Re: Cypress Creek Renewables – Rock District Solar LLC public comments

All of the following comments are based on the final FEAF Part 1, September 8, 2022 by Jason Dickey (TRC Companies; Sponsor) on behalf of the applicant Cypress Creek Renewables for the Rock District Solar project. This review also includes FEAF Parts 2 and 3 as submitted to the Town of Carlisle on December 13, 2022.

Cave Mistake Watershed

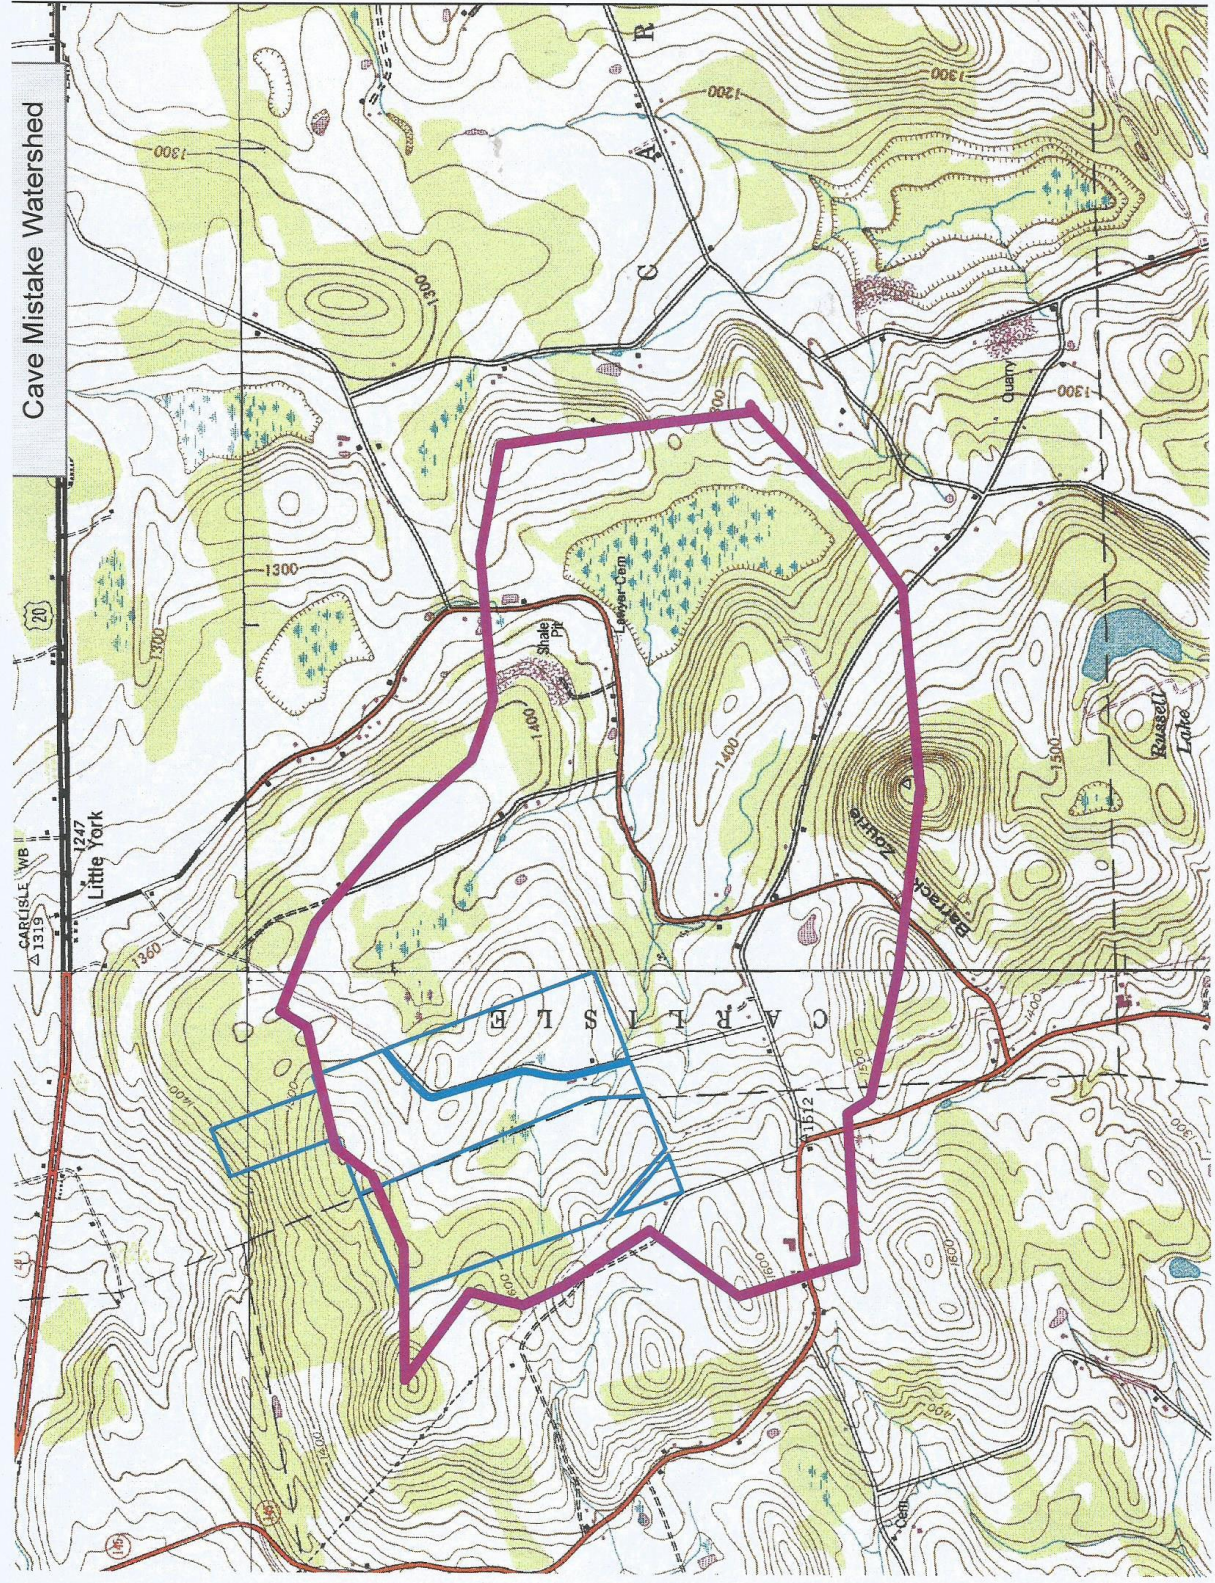
Attachments Map 3 is a corrected watershed map which shows that all drainage from the project site flows to the southeast. Blue line streams on this map are perennial which are also documented in the TRC report. All runoff from the site flows a short distance to closed depression. This outlet to this depression is known as Cave Mistake which is located adjacent to the shoulder of Little York Road.

Figure 3 - Topographic map of the Cobleskill Plateau showing major karst features. Contour interval is 20 feet.

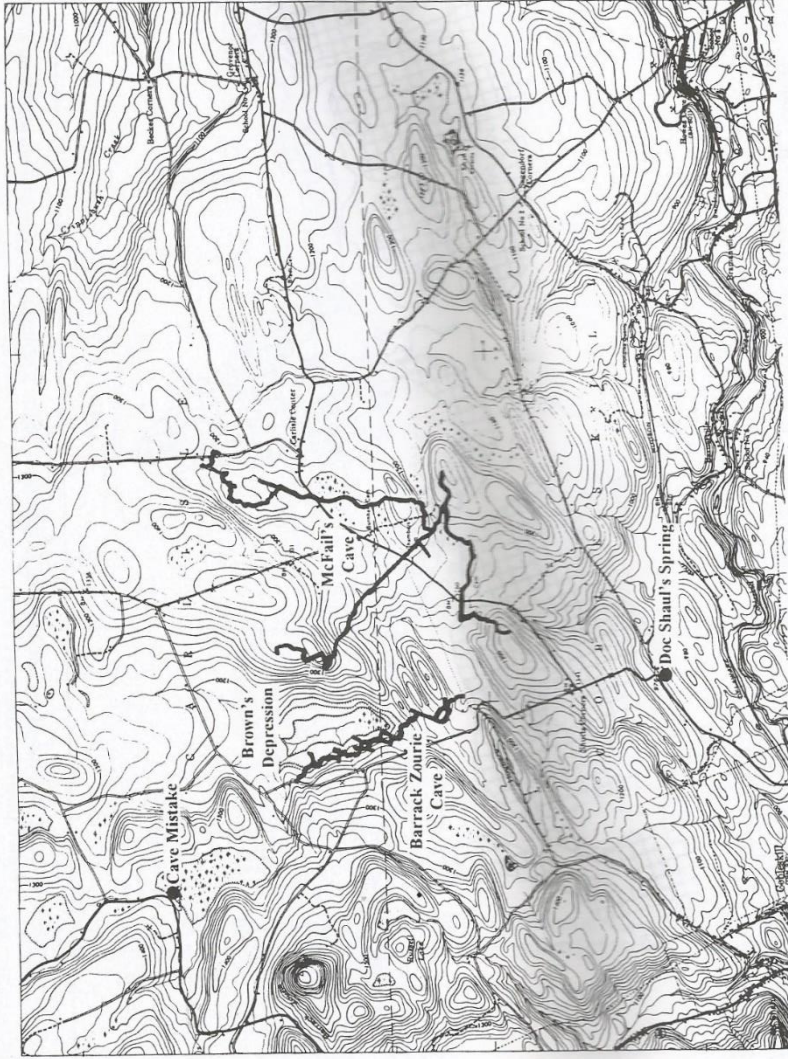
Attachment Map 4 Locates Cave Mistake and other identified karst features in the Cobleskill Plateau.

Figure 4 - Map of Cobleskill Plateau showing relative locations of all major karst features. Arrows indicate flow routes. Suspected flow routes are signified by question marks.

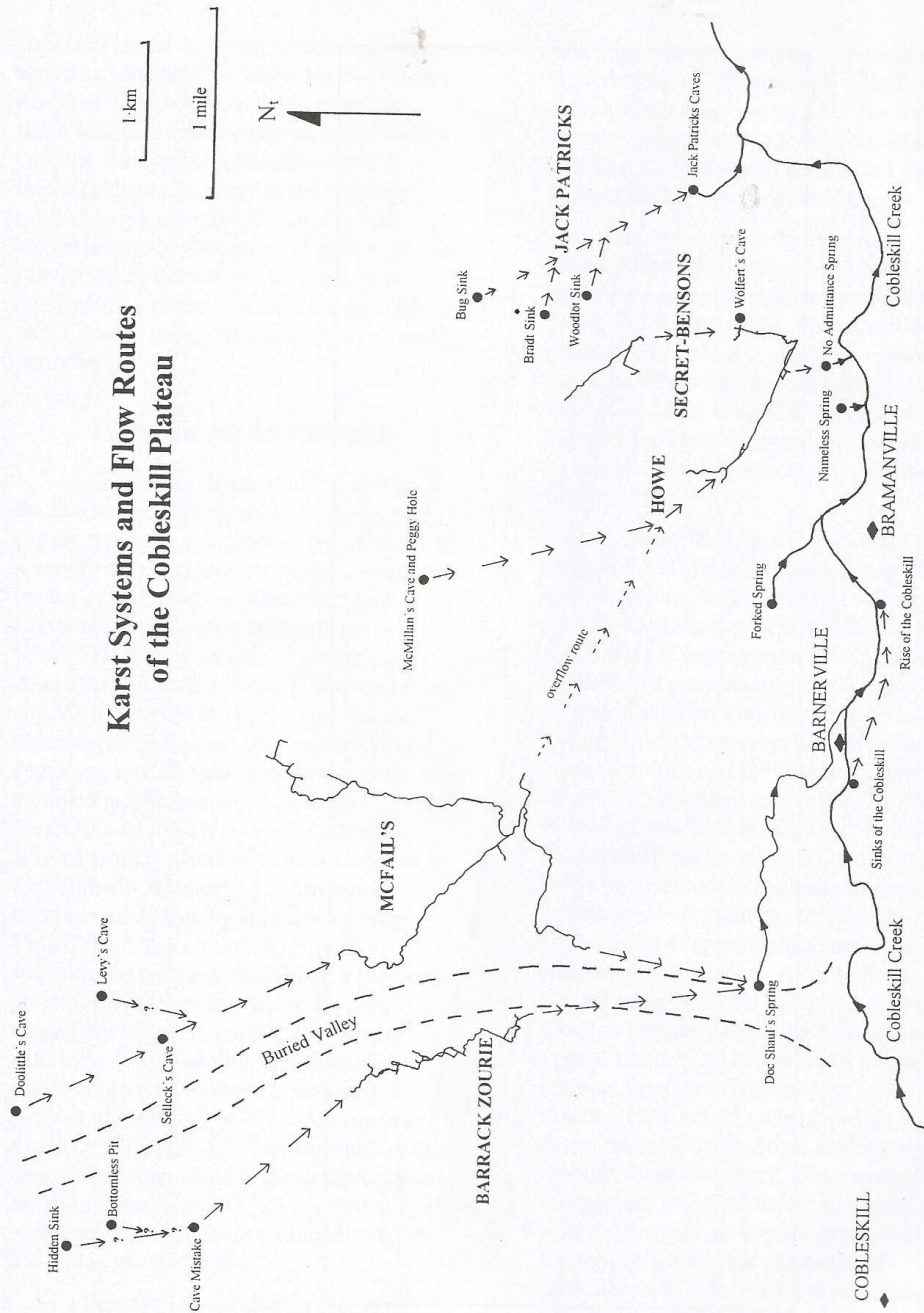
Attachment Map 5 Karst Systems and Flow Routes of the Cobleskill Creek. This maps documents the hydraulic connection between many identified sinks in the northern reaches of the plateau and the associated resurgences located along the northern fringes of the Cobleskill Creek valley.
